From: Conroy, Randy (DEQ)
Sent: Tuesday, May 29, 2012 1:59 PM
To: Coluccio, Tina (DEQ)
Subject: FW: Kennecott Humboldt Mill Septic Denial etc.
Attachments: HumMillStatus5-24-12.pdf

From: Patrick Jacuzzo [<mailto:PJacuzzo@mqtcty.org>]
Sent: Thursday, May 24, 2012 2:51 PM
To: Wolfe, Rob (DEQ)
Cc: Conroy, Randy (DEQ); Fred Benzie
Subject: Kennecott Humboldt Mill Septic Denial etc.

RE: Permit site evaluation and engineering plan review for proposed Type II non-transient, non-community public water supply and industrial non-potable water supply wells.

RE: Permit site evaluation and engineering plan review for proposed commercial sub-surface sewage disposal system.

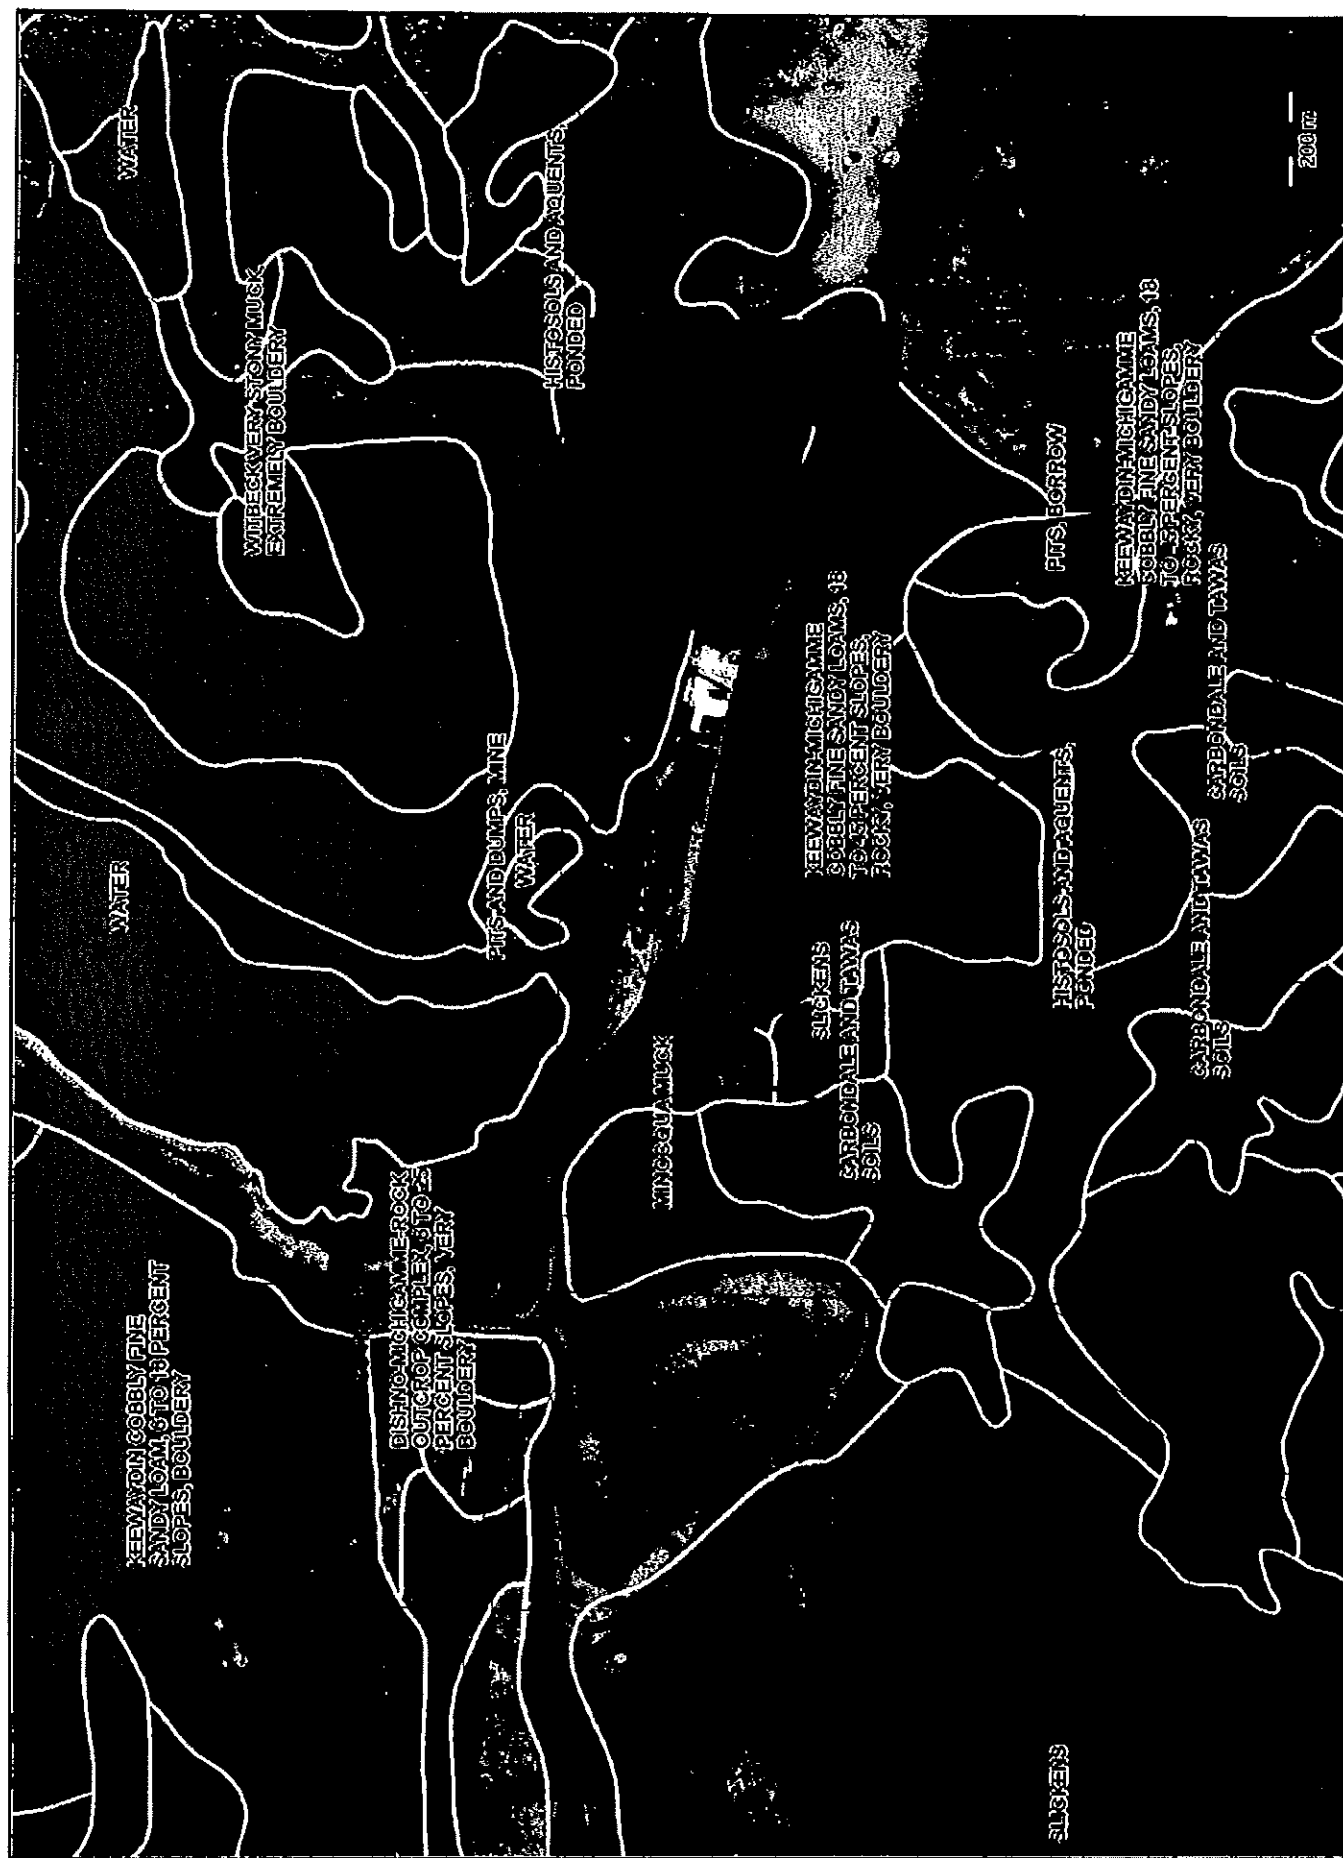
** UNABLE TO ENTER TEST HOLES OR TO APPROACH WITHIN 10 FEET OF THE TEST HOLE PER MINING SAFETY POLICY. TEST HOLE OBSERVATIONS ARE BASED ON EXCAVATION OBSERVATIONS AND EVALUATION OF SPOILS PILES.**

Depth (feet)	Test Hole #1 Soil Texture & Structure	Perc min/in	Water Table	Depth (feet)	Test Hole #2 Soil Texture & Structure	Perc min/in	Water Table	
1	<div style="writing-mode: vertical-rl; transform: rotate(180deg);"> MINING TAILINGS GRANITE ROCK LARGE BOULDERS SOME LOAMY SAND INTERSPERSED COMPACTED </div>	<div style="writing-mode: vertical-rl; transform: rotate(180deg);"> DYS - ESTIMATED </div>	<div style="writing-mode: vertical-rl; transform: rotate(180deg);"> NOT DETECTED </div>	1	<div style="writing-mode: vertical-rl; transform: rotate(180deg);"> MINING TAILINGS GRANITE ROCK LOAMY SAND, TIMBERS RAILROAD TIES. H₂O coming in Hole at approximately 6' </div>	<div style="writing-mode: vertical-rl; transform: rotate(180deg);"> DYS - ESTIMATED </div>	<div style="writing-mode: vertical-rl; transform: rotate(180deg);"> NOT DETECTED </div>	1. Parcel Size: Acres. 3.99
2				2. Slopes - area to be excavated 0-5%

3				3. Surface water: Name: Unnamed ponding Distance: >100 feet Direction: South				
4				4. Owner advised - DEQ permit(s) may be required for: <input checked="" type="checkbox"/> NA <input type="checkbox"/> Flood plain Filling <input type="checkbox"/> Wetland Filling				
5				5. Replacement area: <input type="checkbox"/> Proposed and replacement areas are the same. <input checked="" type="checkbox"/> See sketch for alternate location. <input type="checkbox"/> N/A - replacement area				
6				6. Replacement area soils: <input checked="" type="checkbox"/> See test hole 2 <input type="checkbox"/> Soils are expected to be consistent with Test Hole.				
7				7. Comments: Site is all compacted granitic mining tailings. Soils are unsuitable. Variance required with MDEQ support.

☐ Test Hole (Site) Meets Suitability Stds
☐ Special Const. Criteria-See Permit
☒ Test Hole (Site) Denied-See Comments

Approximate test hole
locations.

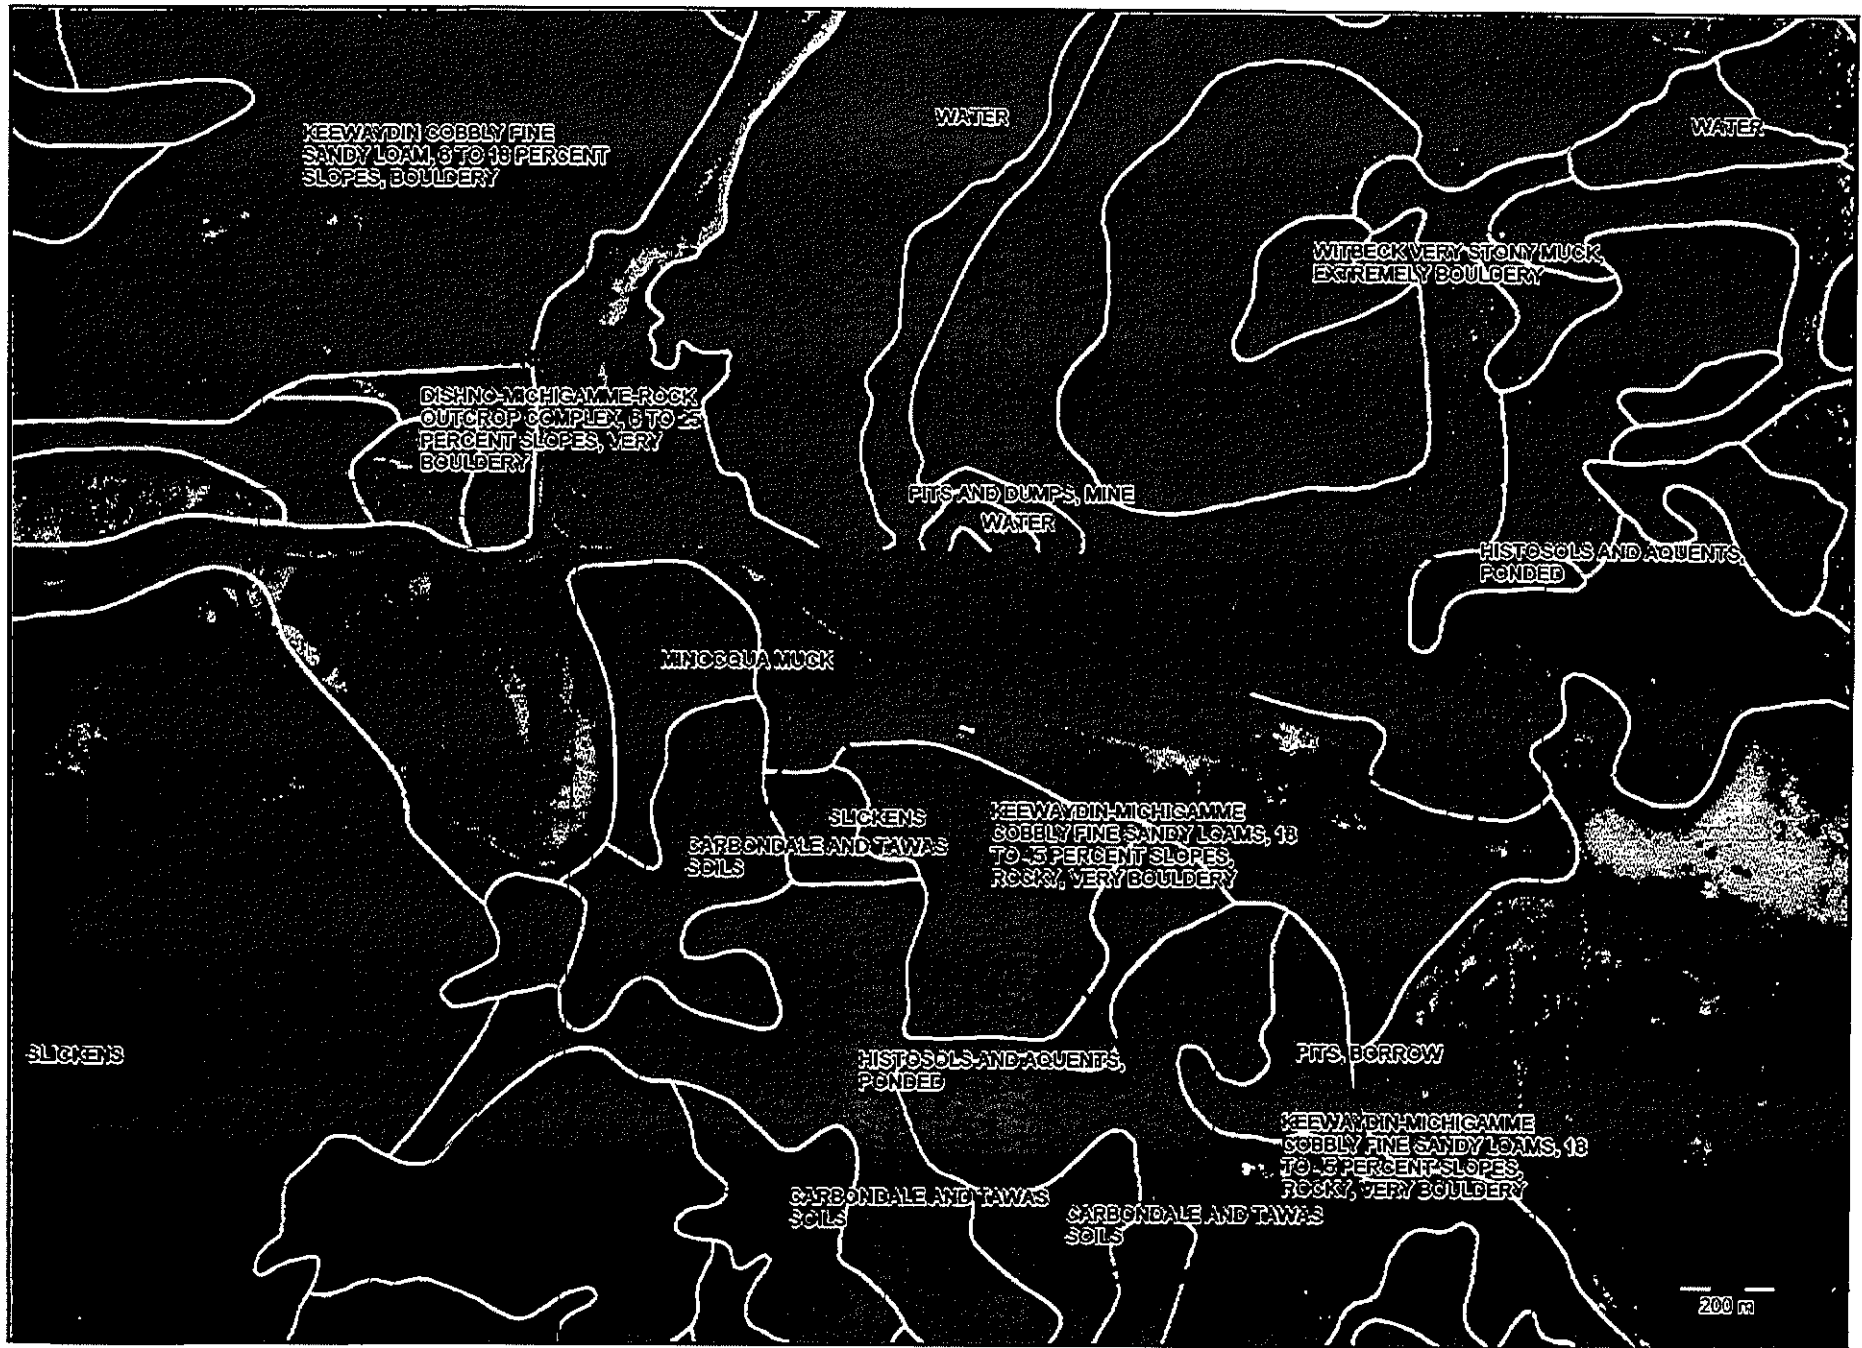
The test holes revealed extremely compact fill materials comprised of granitic mine tailings with some very large boulders in the primary drainfield area. The replacement area test hole revealed mine tailings, timbers and rail ties with water table at approximately 6 feet. We were prohibited from entering and were not permitted to approach to within 10 feet of the test holes due to facility safety rules. Soils are very compacted, predominantly large chunks of rock and are not suitable for infiltration. As such the site was denied.
